Product Change Notice (PCN)

PCN Number: PCN-0334008R-01

CMC-5044PF-A
CMC-5042PF-AC
CMC-2742PBJ-A

CMC-5044PF-A

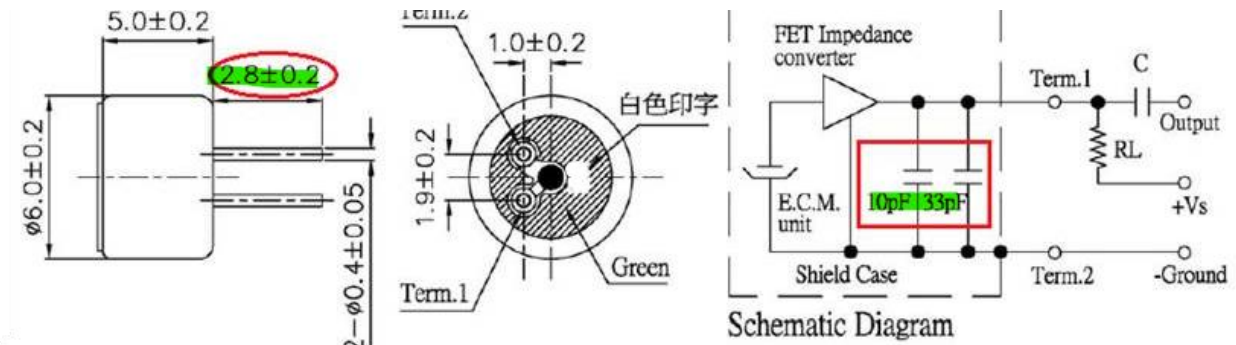
To ensure lead times are not being extended with shortage of material we have changed to a new PCB supplier and will be using a PCB with a 2.8 mm pin length and a 10pf + 33pf capacitor. Adding the two additional capacitors will be helpful on anti-interference at high frequency.
